ARCHITECTURAL REVIEW BOARD MEETING

PLANNING AND ZONING COMMISSION MEMORANDUM

TO: Planning and Zoning Commission
DATE: July 9, 2024
APPLICANT: Keaton Mai; *The Dimension Group*
CASE NUMBER: SP2024-025; *Site Plan for a Restaurant 2,000 SF or More w/ Drive Through or Drive in*

SITE PLAN
 LOT 15, BLOCK A, CREEKSIDE COMMONS
 ADDITION
 NWC STATE HIGHWAY 205 & F.M. 549
 A 0.67 ACRE TRACT OF LAND IN THE
 WILLIAM W. FORD SURVEY, ABST. NO 80
 CITY OF ROCKWALL, ROCKWALL
 COUNTY, TEXAS
 CITY PROJECT #SP2024-025
 June 27, 2024

1 ELEVATION - SOUTHWEST (ADJACENT TO R.O.W.)
 3/16" = 1'-0"

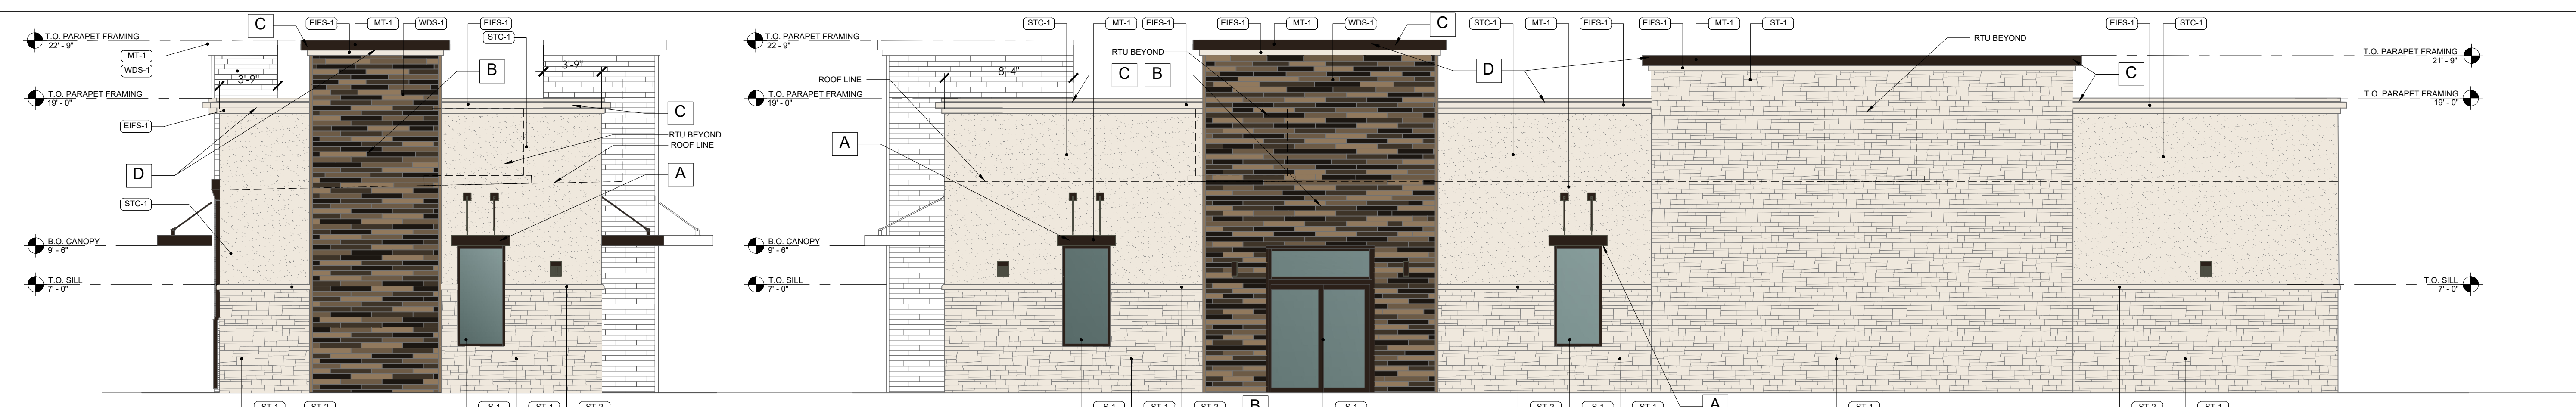
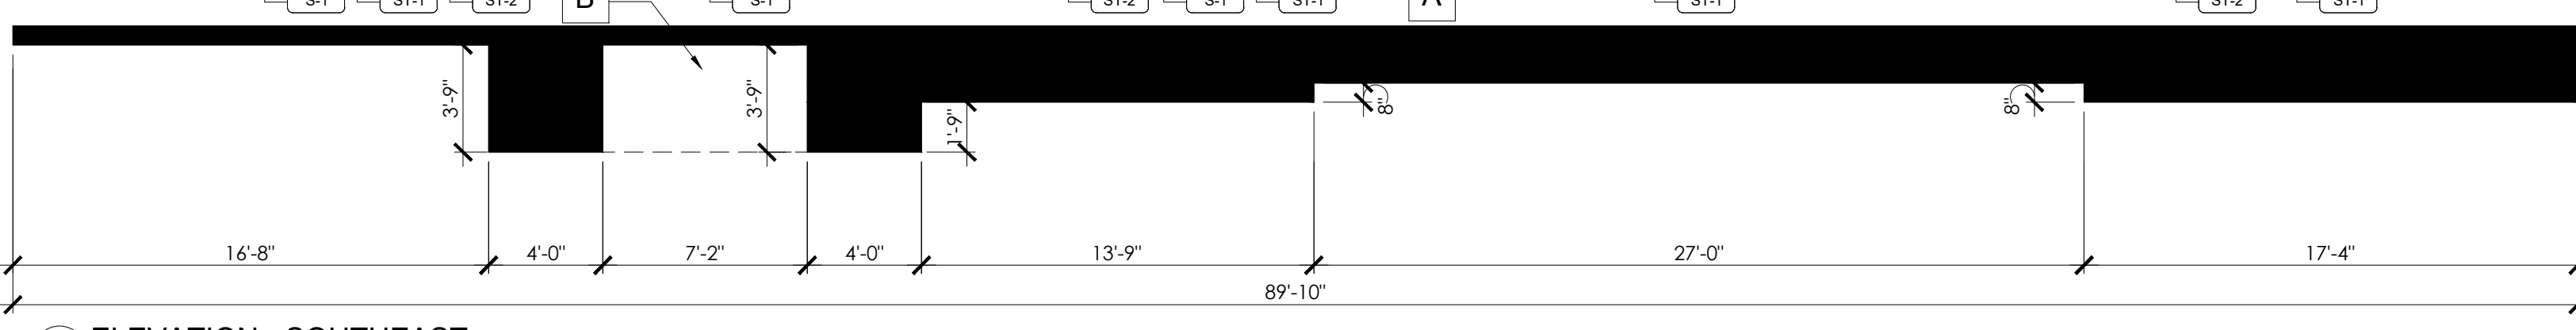
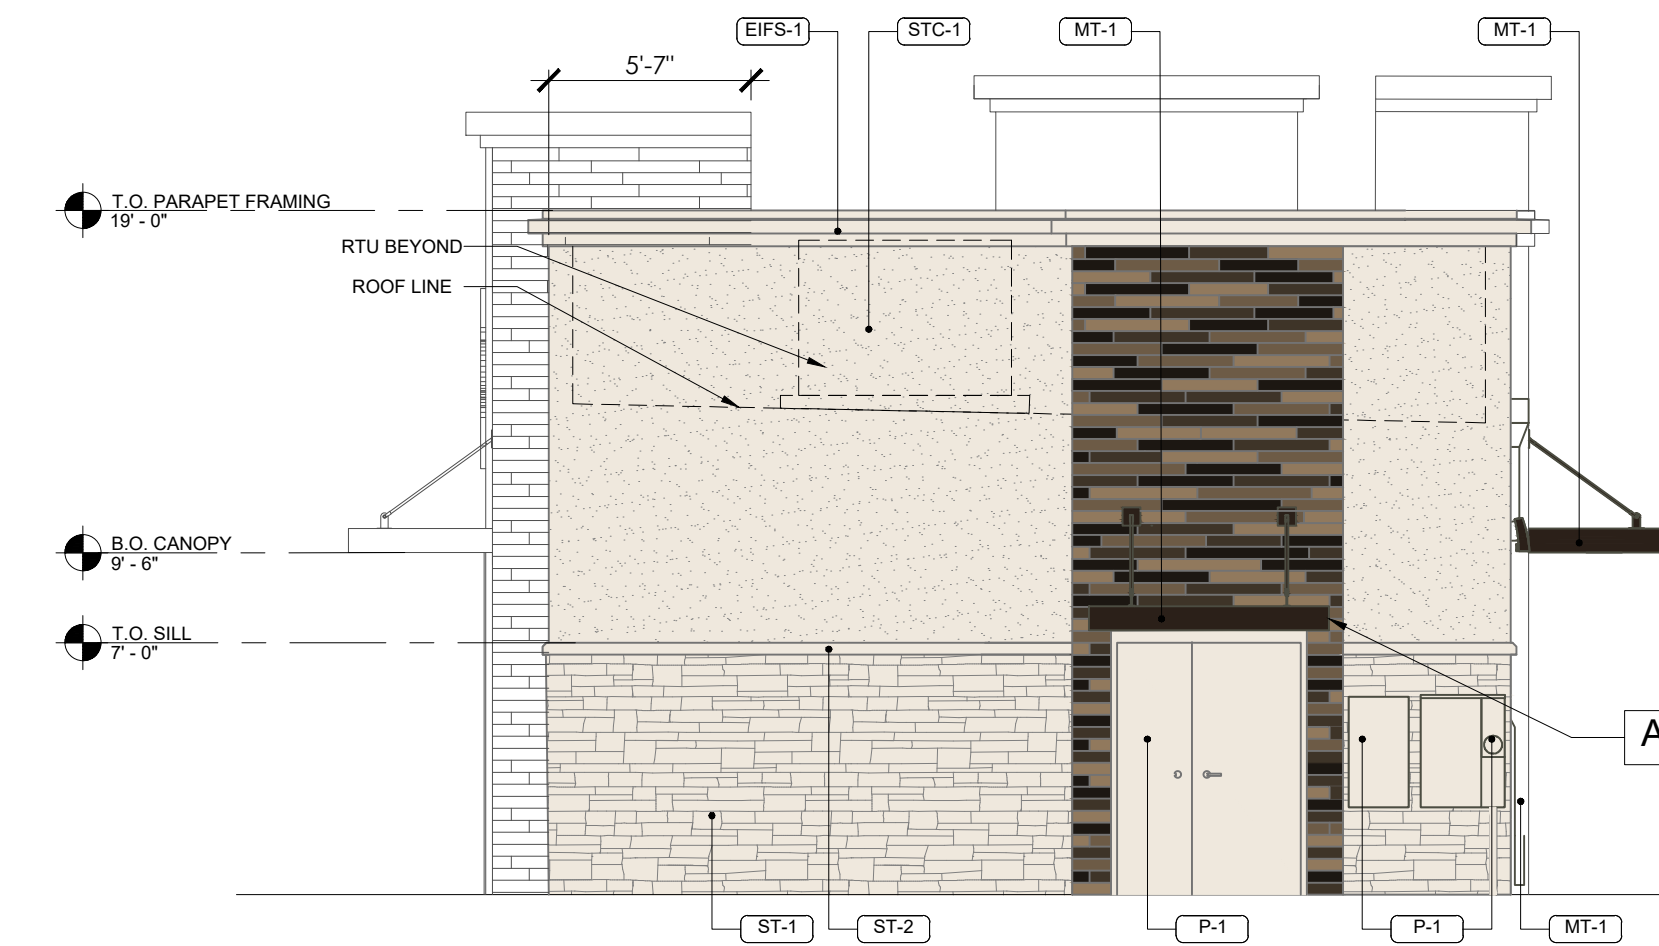
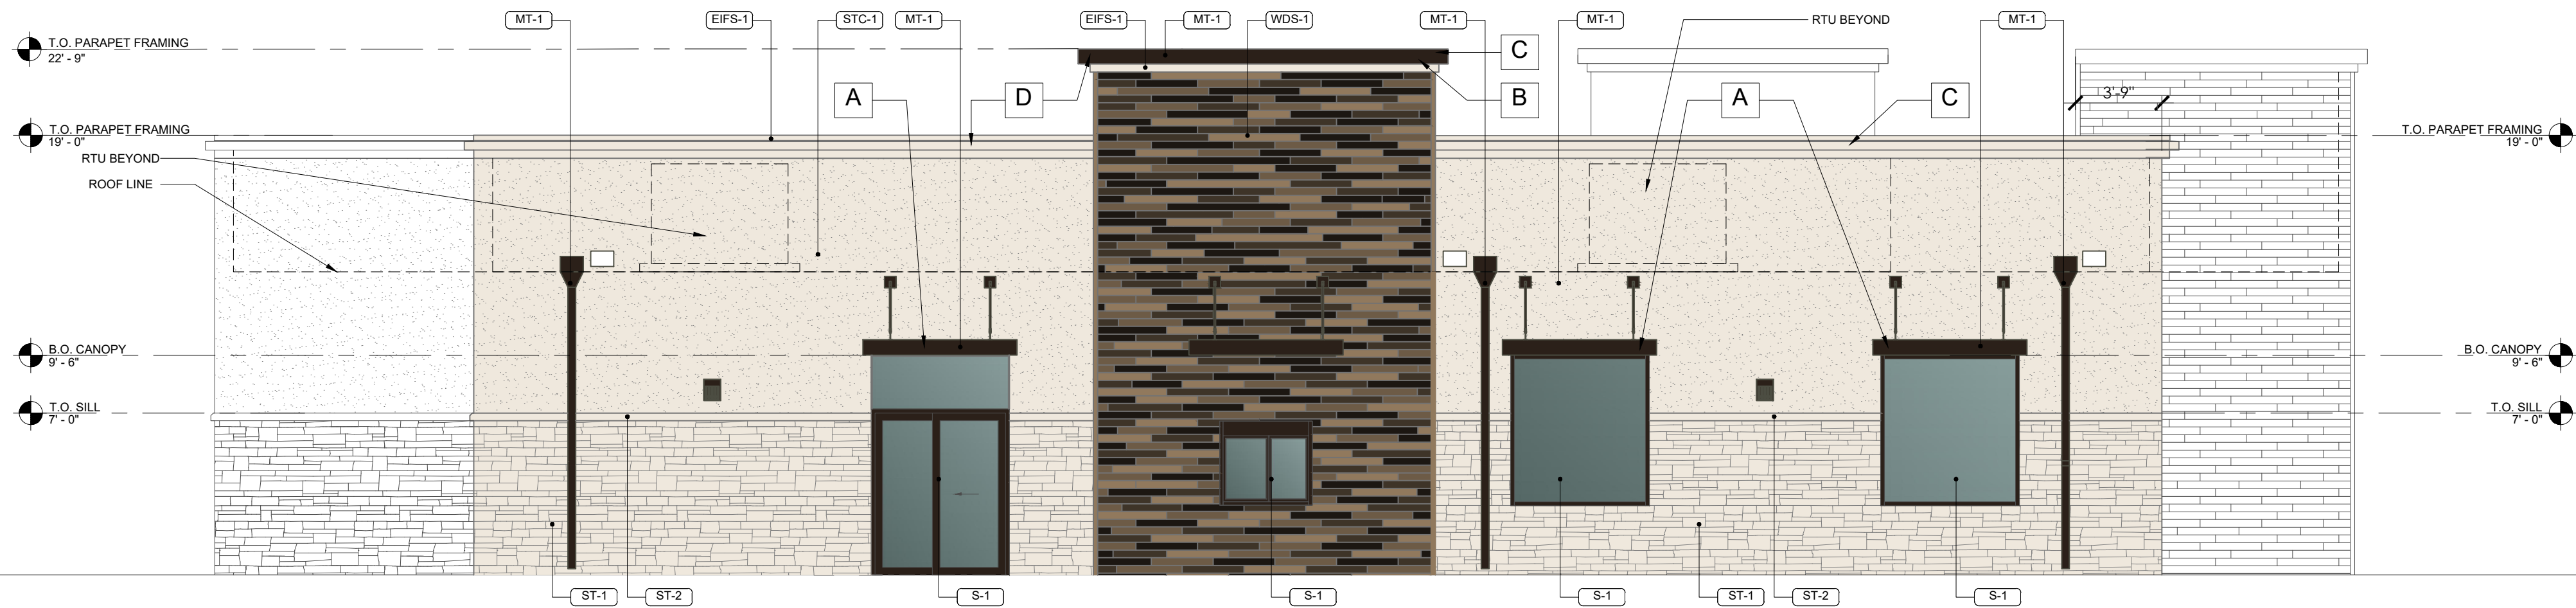
- (c) 90% Masonry Requirement. According to Subsection 06.02(C)(1), *Materials and Masonry Composition*, of Article 05, *District Development Standards*, of the Unified Development Code (UDC), "...each exterior wall of a building's façade shall consist of a minimum of 90% Primary Materials..." In this case, the applicant does not meet this requirement on any of the of the building facades. Specifically, they are proposing more than ten (10) percent composite lumber material on each elevation to match the HTeaO brand. This will require a Variance from the Planning and Zoning Commission.

On May 28, 2024, the Architectural Review Board (ARB) reviewed the proposed building elevations. The ARB requested to see revised building elevations that incorporated more of the articulation requirements. The ARB will review the updated building elevations and provide a recommendation before action is taken by the Planning and Zoning Commission at the June 25, 2024 meeting.
